CONSTRUCTION PLAN APPROVAL

## THE VISTAS PHASE 4

### LAKE COUNTY, FLORIDA

**CASING DETAIL**  
NTS

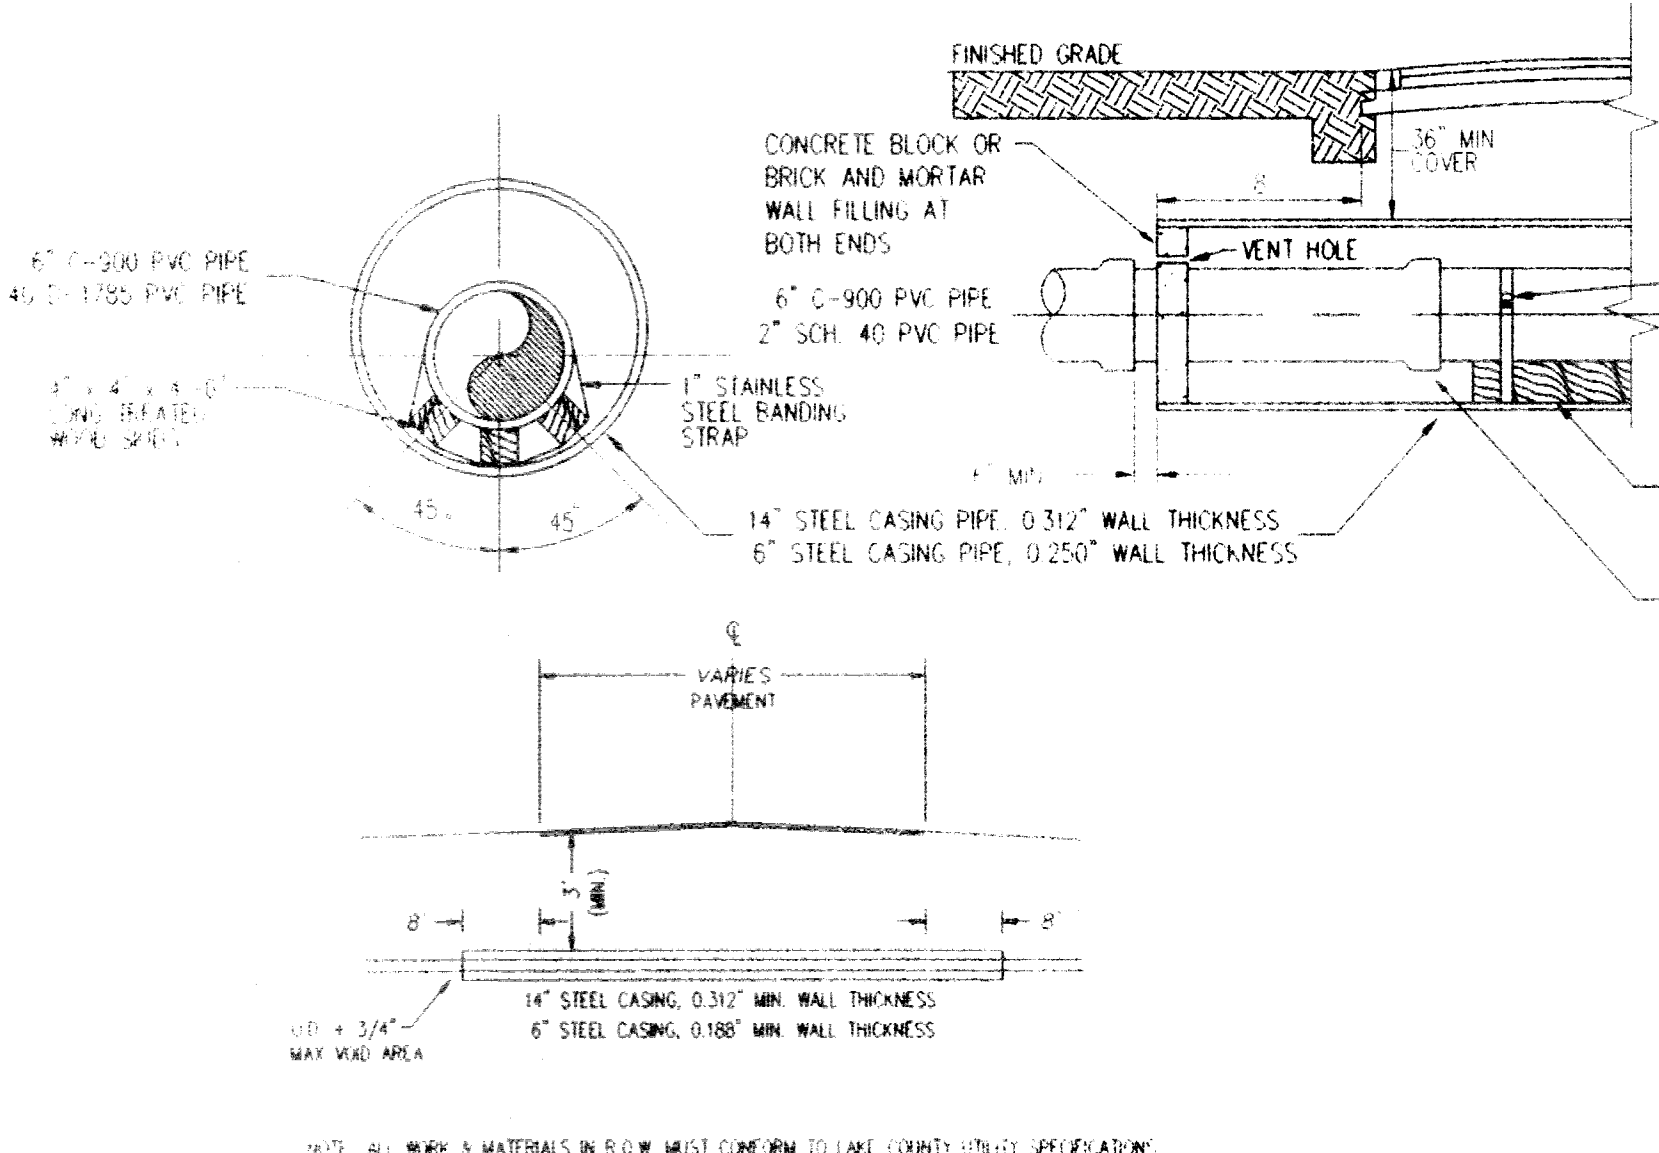
- \* All pipe crossings under roadway to have 98% comp. 6" lifts 12" density EACH Lane.
- \* All pressure lines under roadway to be increased or D.I.P.
